# Access Compliance Report

## Public Rights-of-Way

### (Pedestrian Signals)

Intersection ID: N/A	Main Street:	Cross Street: N/A	Location: N/A
ADA ID: 224C594E9211	Signal Type: One Push Button-APS	Overall Compliance: No	Severity Score: BTN 1: N/A BTN 2: N/A No BTN: N/A
Codes/Mitigation Info/Possible Solution		Field Measurements/Component Compliance

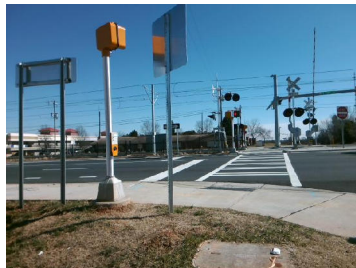
PROW/ADA: TMUTCD 4e.08, R404.2, R404.7.3, R404.7.2, R209.1, MUTCD 4e.10

N/A	B 1 Clear Xing Direction?	Yes	N/A	B 2 Clear Xing Direction?	N/A
	B 1 Crossing Direction	To E		B 2 Crossing Direction	N/A
Yes	B 1 DistanceTo XWalk (in)	8.0	N/A	B 2 DistanceTo XWalk (in)	N/A
No	B 1 DistanceTo Curb (in)	96.0	N/A	B 2 DistanceTo Curb (in)	N/A
Yes	B 1 Diameter (in)	2.0	N/A	B 2 Diameter (in)	N/A

Possible Solutions: Replace Signal Push Button With APS Button on New Post. Remove & Relocate Sign.
